Subject: 10 CFR Part 21 Report Notification, CON2000 and RTD2100 Spring Clips

# TECHNICAL BULLETIN

Subject: CON2000 & RTD2100 Spring Clips

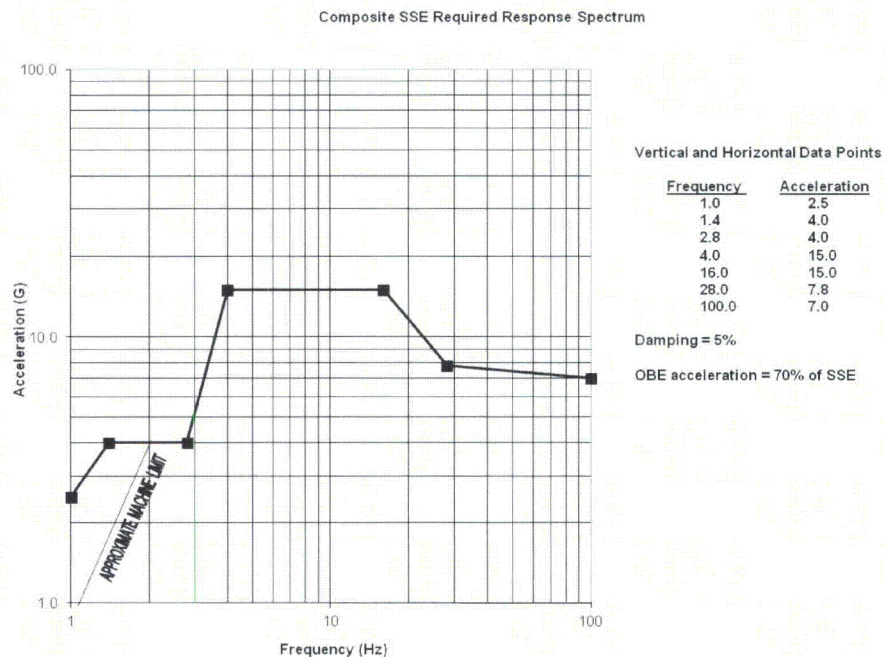
Investigation revealed that the original clip was made of 0.025" thick spring steel. After the seismic qualification test was performed, Revision 4 to NUS-F089DB-13 altered the characteristics of the retaining clip, reducing the force required to disengage the detent. The metal was changed to SS301 stainless steel and the thickness reduced to 0.015" thick. Scientech's design change process required an evaluation of the impact on qualification; the evaluation was either not completed or not adequate.

These controllers could be mounted in the main control room control panels. The failure of the seismic clip could result in the controllers coming out of the panels, impacting other safety related equipment or personnel, and failing to properly control their actuated devices during a seismic event.

Scientech will provide 0.025" spring steel clips as used in the original qualification test with installation instructions to all affected plants. The spring clips are easily replaced in the field.
